SUBJECT: Forest County Potawatomi Legacy District
GPD and DPD Submittals
Common Council File Numbers 050469 and 050468

Attached are revisions to the General Plan Development (GPD) and Detailed Plan Development (DPD) for the Forest County Potawatomi Legacy District, as identified in John Hyslop's September 7, 2005 letter. The following items are enclosed.

FOREST COUNTY POTAWATOMI LEGACY DISTRICT

DETAILED PLAN DEVELOPMENT

DPD-10C

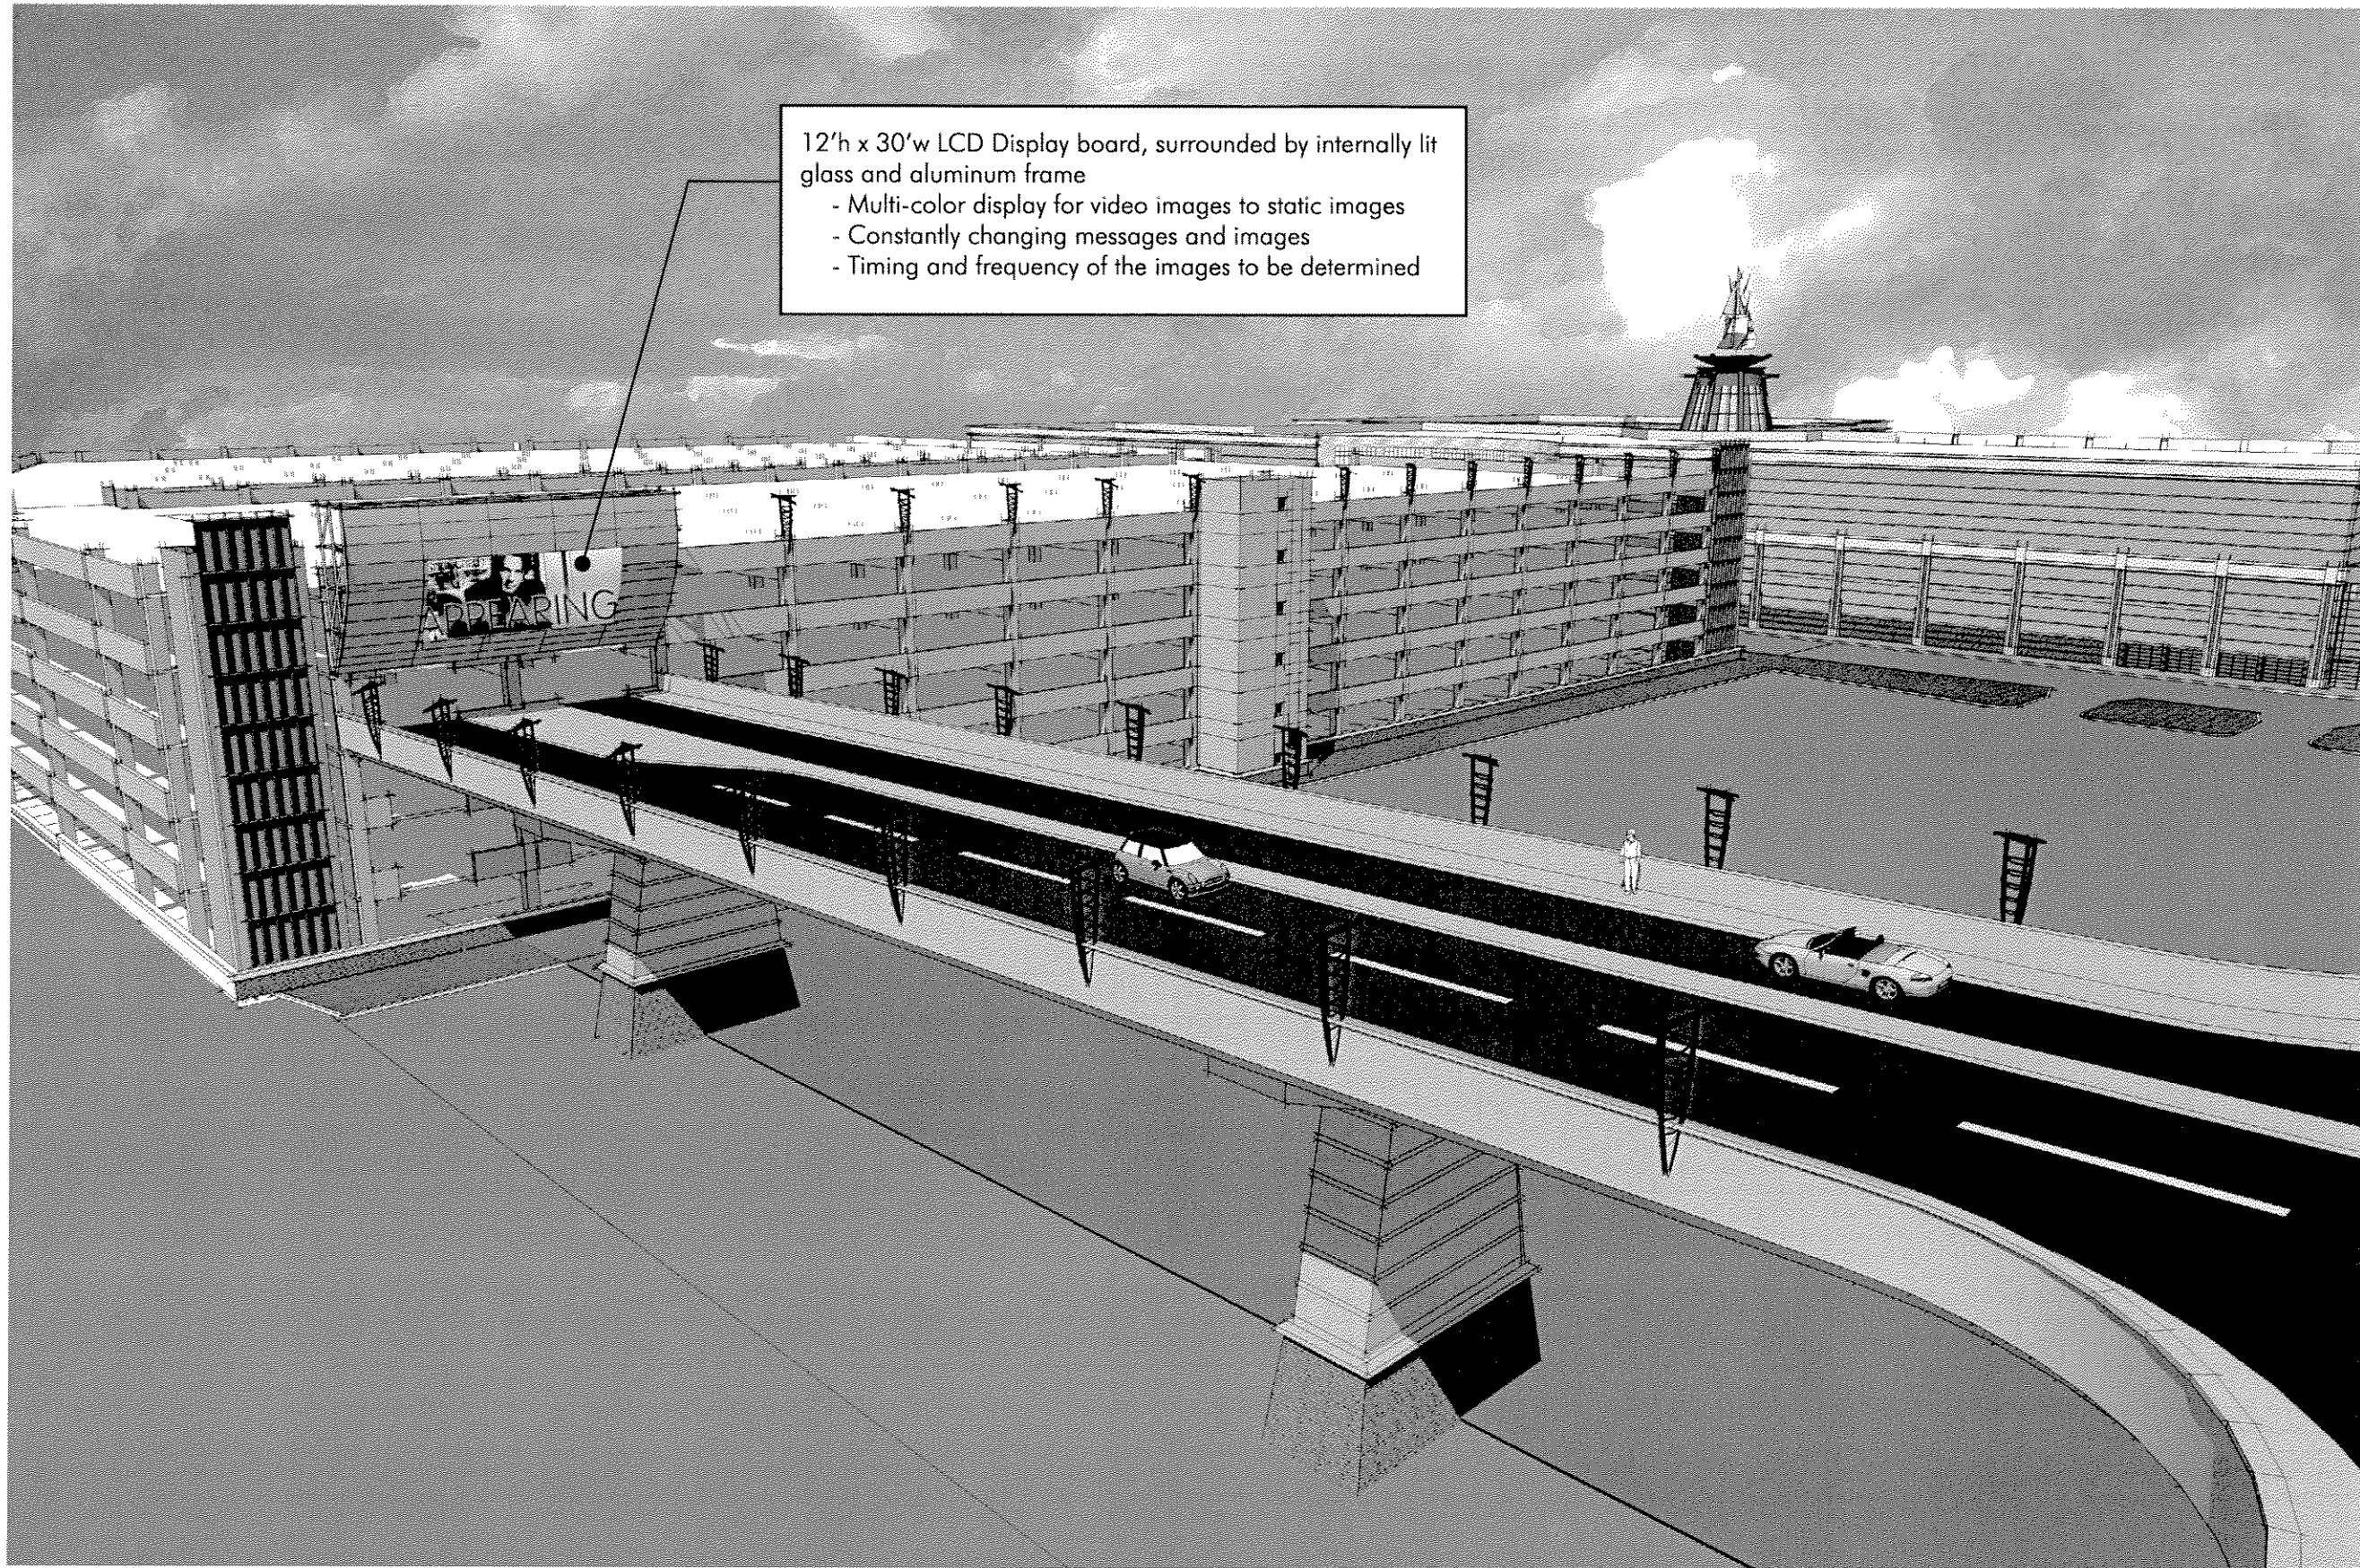
- Revised Sheet DPD-10C, Showing the sign details for the LCD display board sign at the proposed vehicular bridge connection. (2 copies)
- Revised GPD Project Description and Owner's Statement of Intent. Changes are as follows:

12'h x 30'w LCD Display board, surrounded by internally lit glass and aluminum frame

- Multi-color display for video images to static images
- Constantly changing messages and images
- Timing and frequency of the images to be determined
